CREEKWOOD SUBDIVISION, UNIT III

APPLICATION NUMBER 4 DATE March 6, 2008

DETAIL SITE PLAN

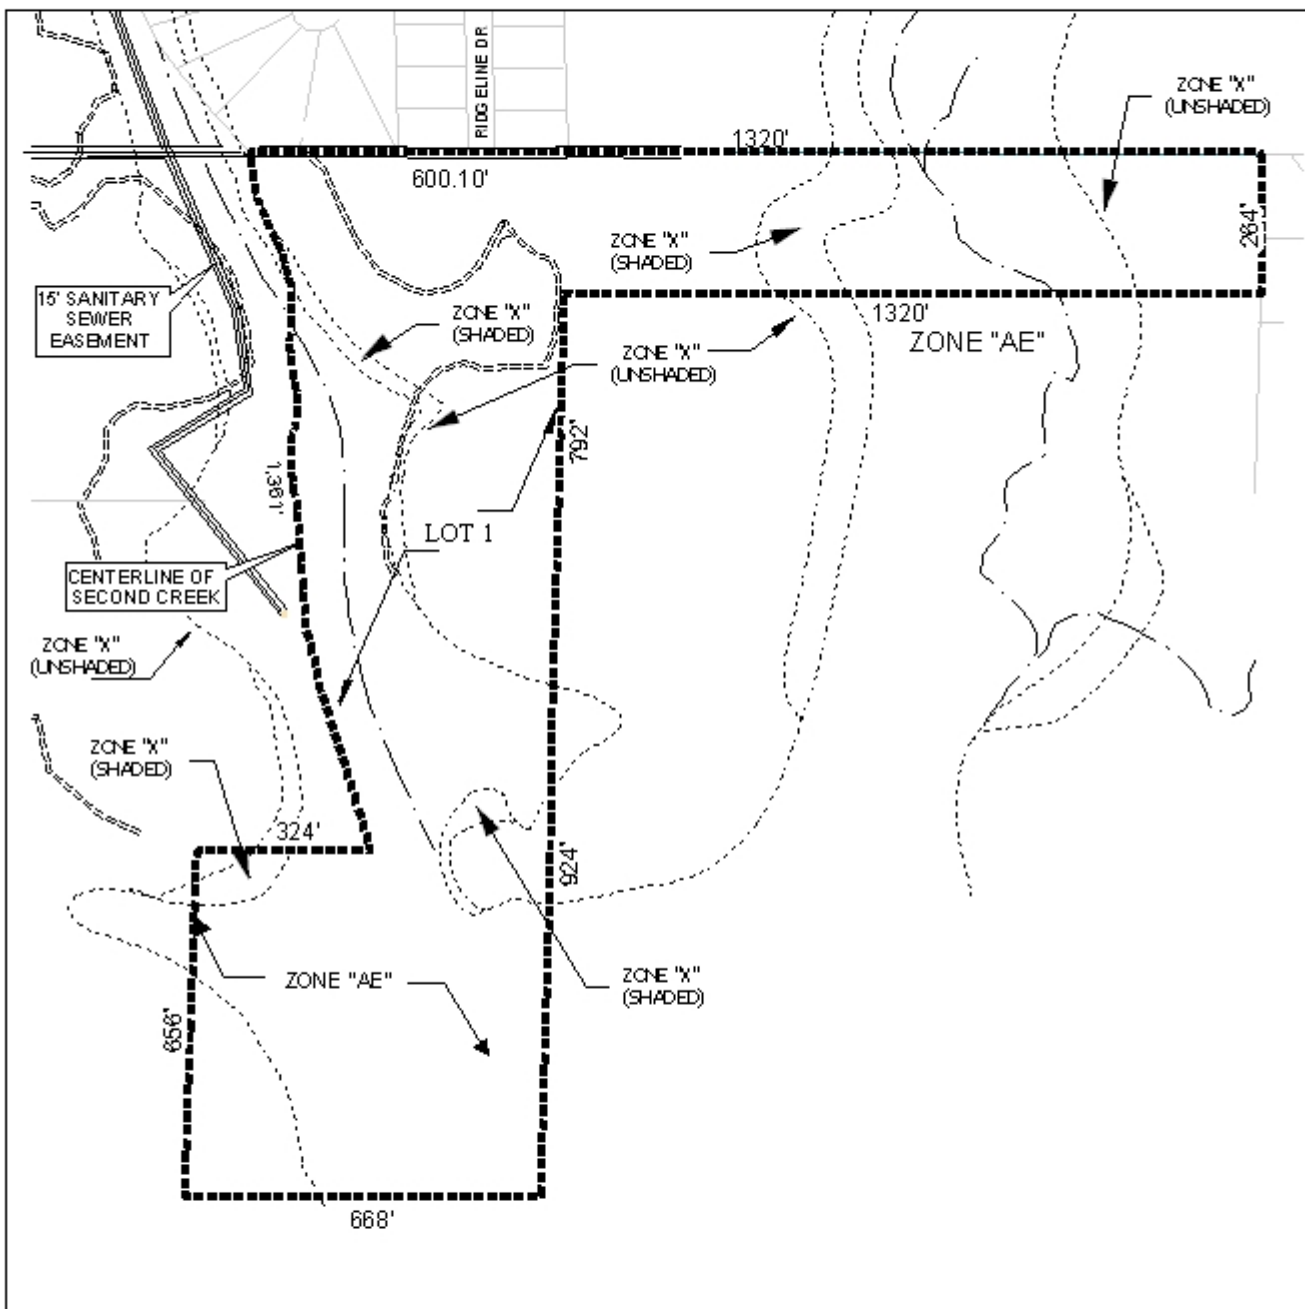
The cul-de-sac at the South terminus of Ridgeline Drive is proposed to have a central median. The site is within the Mobile Fire-Rescue Jurisdiction, and with its recent adoption of the 2003 International Fire Code Standards, a cul-de-sac with a central median requires a 140' diameter. Although not specified on the plat, the cul-de-sac scales at 110' diameter; therefore, the cul-de-sac should be revised to be 140' diameter. Also, the proposed dead-end street stub off the East side of Ridgeline Drive will require a turnaround; therefore, a turnaround approved by the Mobile Fire-Rescue Department should be indicated on the plat.

All proposed lots appear to meet minimum dimensional requirements; however Lots 17 through 23 appear to have just over half the lot encumbered by floodplain for a branch of Second Creek. Several lots also appear to be impacted by the floodway associated with Second Creek. Several of the lots exceed the depth-to-width ratio of Section V.D.3. of the Subdivision Regulations; however, other lots have been recorded in Unit II of a similar nature.

No access is provided to the “common area” South of the area proposed to be developed with this application; therefore, the plat should be revised to provide access to this area from Ridgeline Drive.

The 25' minimum building setback line, required in Section V.D.9., is not shown on the plat, but would be required on the final plat, if approved.

The plat labeled each lot with its size in square feet. This should also be done on the final plat, or a table should be provided depicting the same information.

1. revision of the plat and legal description to remove Parcel #R023303062000003.001, which is a part of the approved Cypress Cove Subdivision;
2. revision of the cu-de-sac at the South terminus of Ridgeline Drive to be 140' diameter as per the 2003 International Fire Code Standards;

3. revision of the plat to include a turnaround at the South terminus of the street stub off the East side of Ridgeline Drive, to be approved by Mobile Fire-Rescue Department;

4. revision of the plat to afford street access to the two land-locked parcels (R023303061000004 and R023303061000004.01) on the East side of the area proposed to be developed;

5. provision of access from Ridgeline Drive to the "common area" South of the area proposed to be developed;
6. placement of a note on the plat stating that approval of all applicable federal, state and local agencies is required prior to the issuance of any permits or land disturbance activities;

11. depiction of the 25' minimum building setback line;
12. labeling of each lot with its size in square feet, or the provision of a table depicting the same information;

13. verification that sufficient buildable area shall be provided for each lot (particularly lots 18 through 22); and
14. placement of a note on the Final Plat stating that any lots which are developed commercially and adjoin residentially developed property must provide a buffer, in compliance with Section V.A.7. of the Subdivision Regulations.
